Old Business

Appeal #5

Kenneth Weinstein
5870 Forest Creek Drive

Appeal No. 5

Right Side Elevation

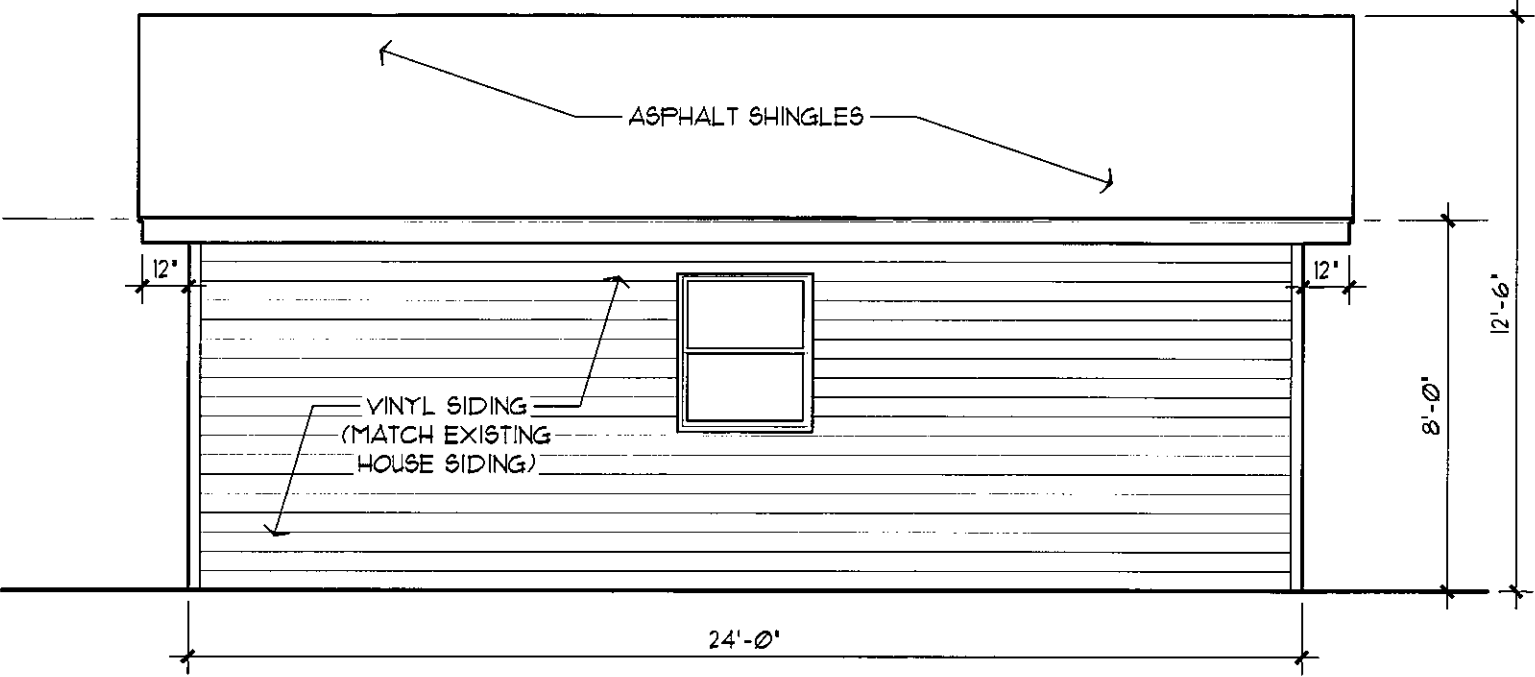
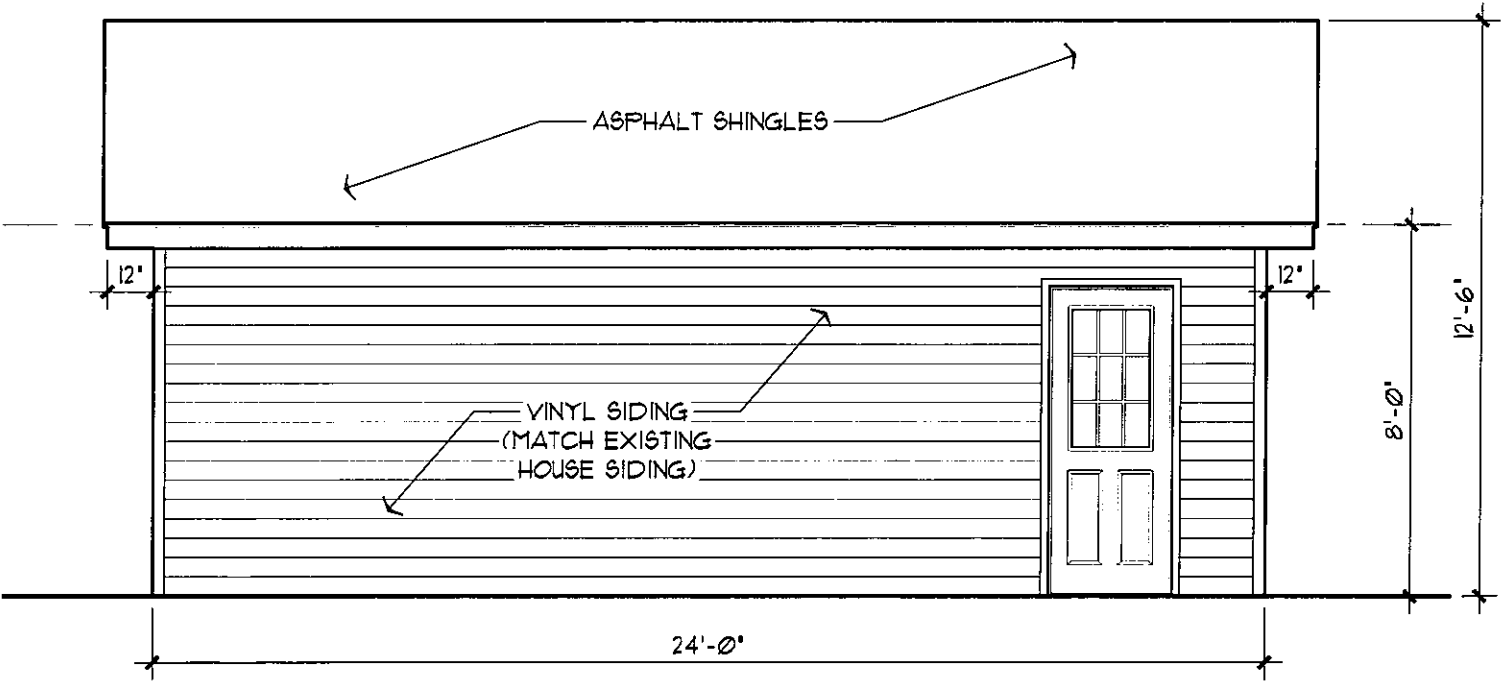
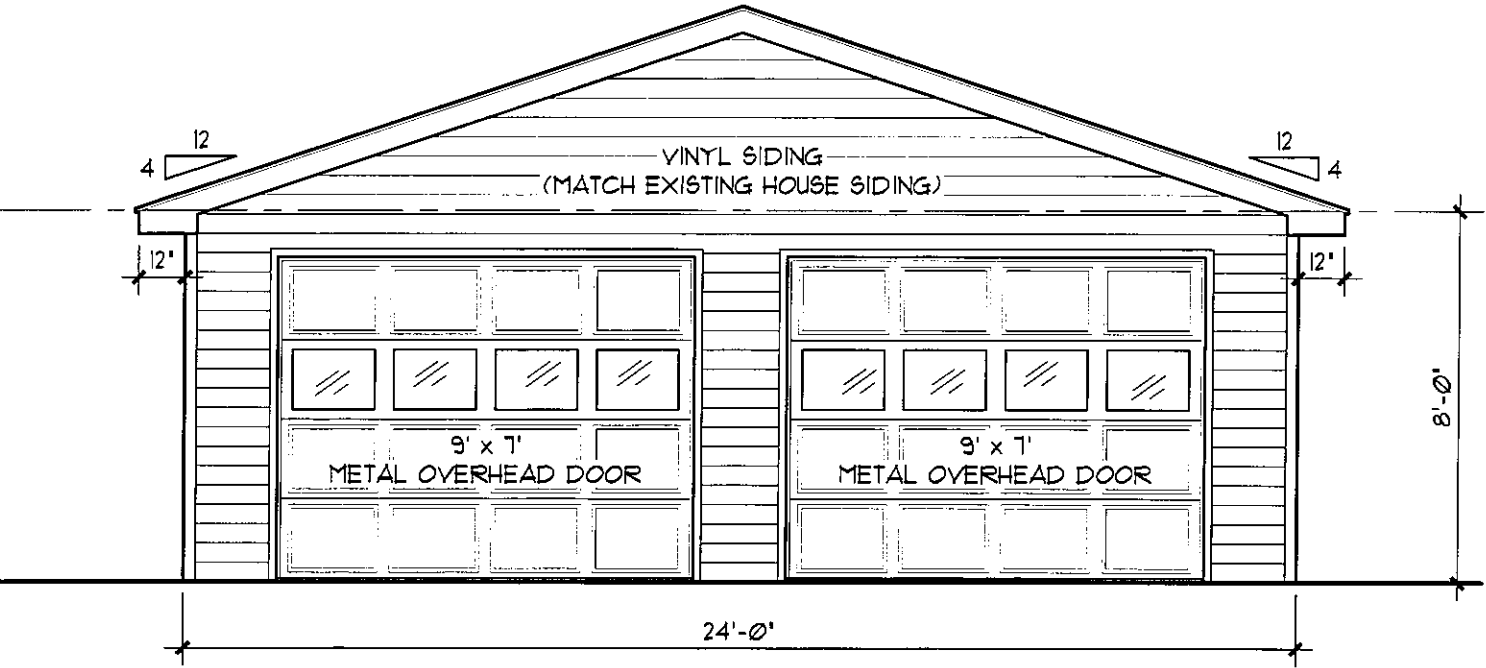
Referring to the elevations that Mr. Weinstein submitted, Mr. McNamara confirmed that is what is being built.

Mr. Drinkard referred to the page of the packet that shows the exterior elevations, and asked if the options provided which are vertical siding, and horizontal siding. Where Mr. Weinstein's house is sided, it is horizontal siding. Mr. Drinkard asked if the proposed garage siding would match the house.

Mr. Drinkard stated that as closely as the proposed garage can be matched to the house is what is preferred. If there is brick on the front of Mr. Weinstein's house, then they prefer there to be brick on the front façade of the proposed garage. Something that compliments the house, and does not look like a completely different building.

Mr. Krey confirmed that Mr. Weinstein would put brick on the front of the proposed garage if the board required it.

Mr. Drinkard reiterated that the siding on the example that the applicant included in his application packet showed vertical siding.

Mr. Krey confirmed with Mr. Drinkard that he wants the siding on the proposed garage to be the same orientation as the siding on the house.

Mr. Drinkard stated that he feels they are at a point where he personally would like to see an elevation. This is a 100' lot in a very nice subdivision, surrounded by very lovely other homes. They do not want to disturb the harmony of the neighborhood, they cannot clearly visualize what it would look like. He would like to see an elevation, or architect prepared elevation at least of the front of the proposed garage.

Mr. Drinkard reiterated that he would like to see an elevation of what the proposed structure will look like.

Mr. Weinstein stated that he would ask for it to be voted on contingent on the stone work in the front, and the horizontal vinyl siding to match the house.

Chairman Mills confirmed with Mr. Weinstein that he wants them to vote on the request with the condition that the front façade is to be either stone or brick to match the house.

New Site Plan

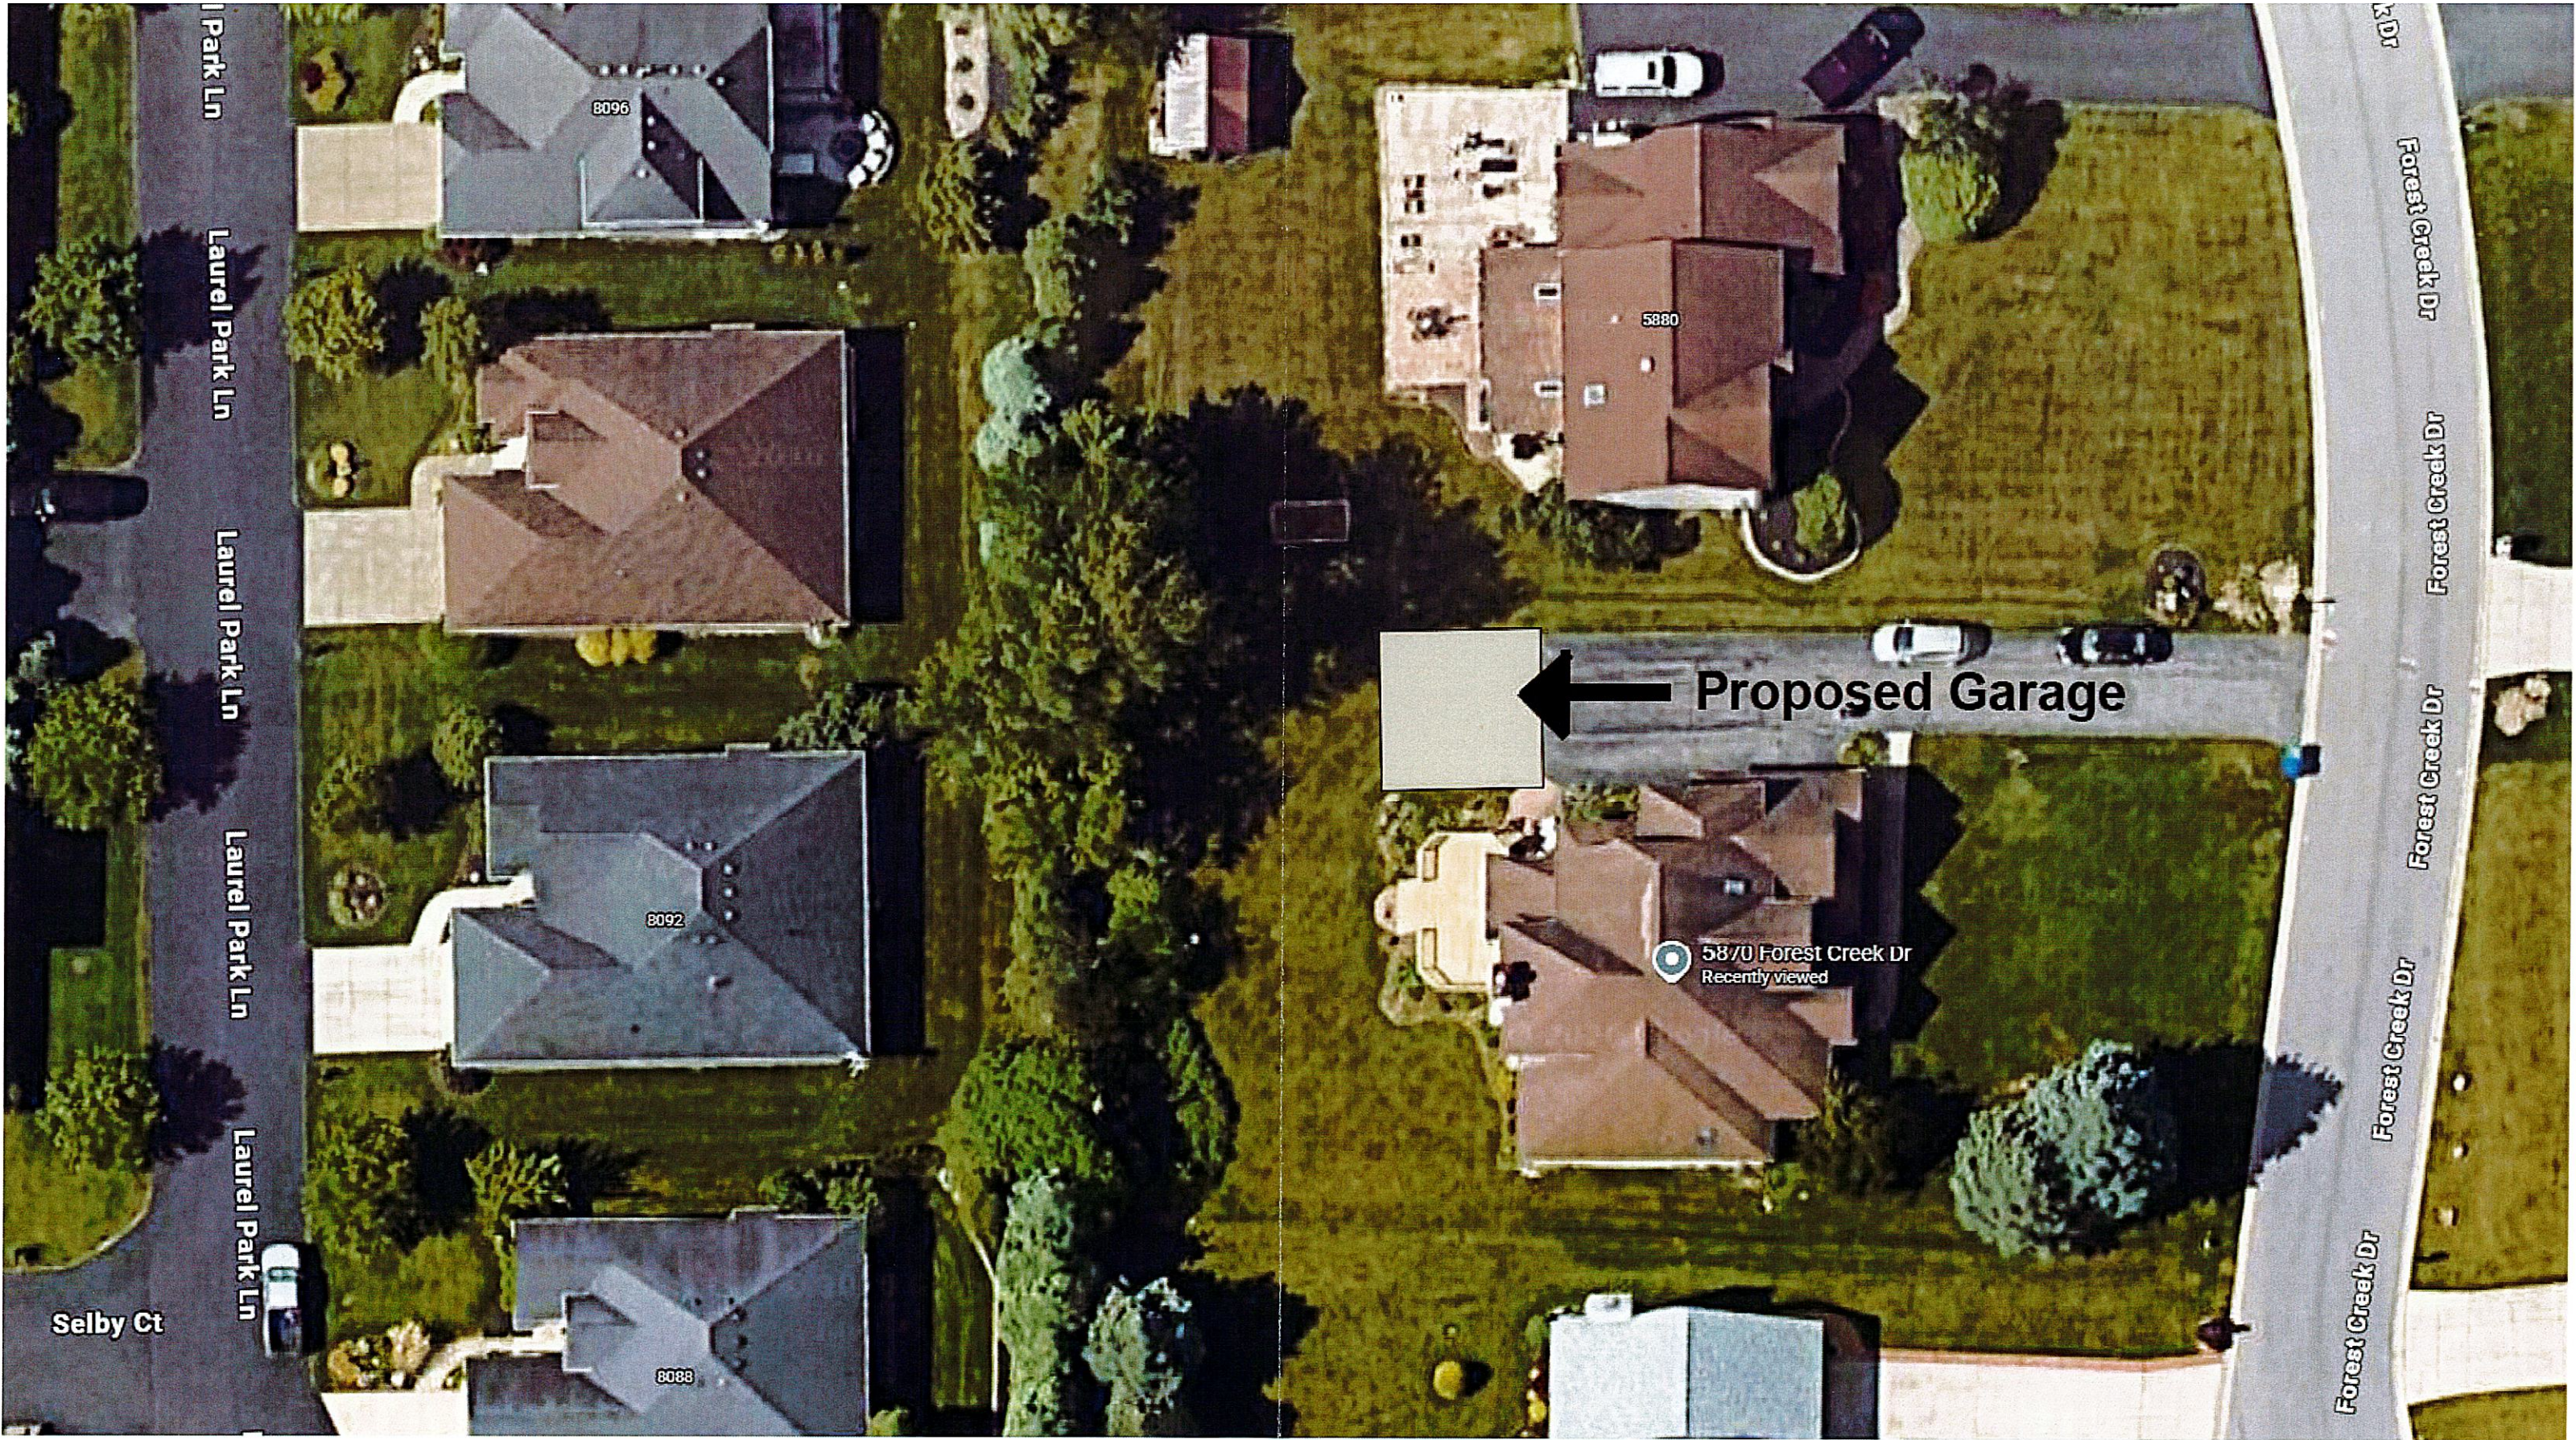
Mr. Dale suggested to Mr. Weinstein that he moves the proposed garage back another 4', and then move it towards the center of the yard 4'. This will eliminate the 4' side yard setback variance request.

Mr. Dale stated okay, that may be true, but then a variance for the side yard would not be needed by moving the proposed garage a little farther away.

Mr. Bleuer explained that they are unsure, as the applicant was not able to provide a foundation or a plot plan. Unfortunately, the office had to make some assumptions in terms of a 24' garage with the house having just under a 30' setback.

Mr. Bleuer stated that he did visit the property, and where the stakes are located does not seem as though there is 6' feet to the property line. Ultimately, the necessary information was not provided to make that determination.

Addressing Mr. Weinstein, Mr. Bleuer highly recommended he hires a design professional to scale out the plan to his survey. His fear is that if Mr. Weinstein eventually receives approval from the Zoning Board of Appeals for a certain distance from the property line, and then upon proceeding to the Building Department, they will require surveyed drawings. If the number is different, he will need to return to the Zoning Board. To do it ahead of time and know what the exact number is, it can then be posted properly and know what the number is.

Mr. Bleuer responded that for the side yard setback, 10' is the legal compliant setback, and the rear yard is 5'.
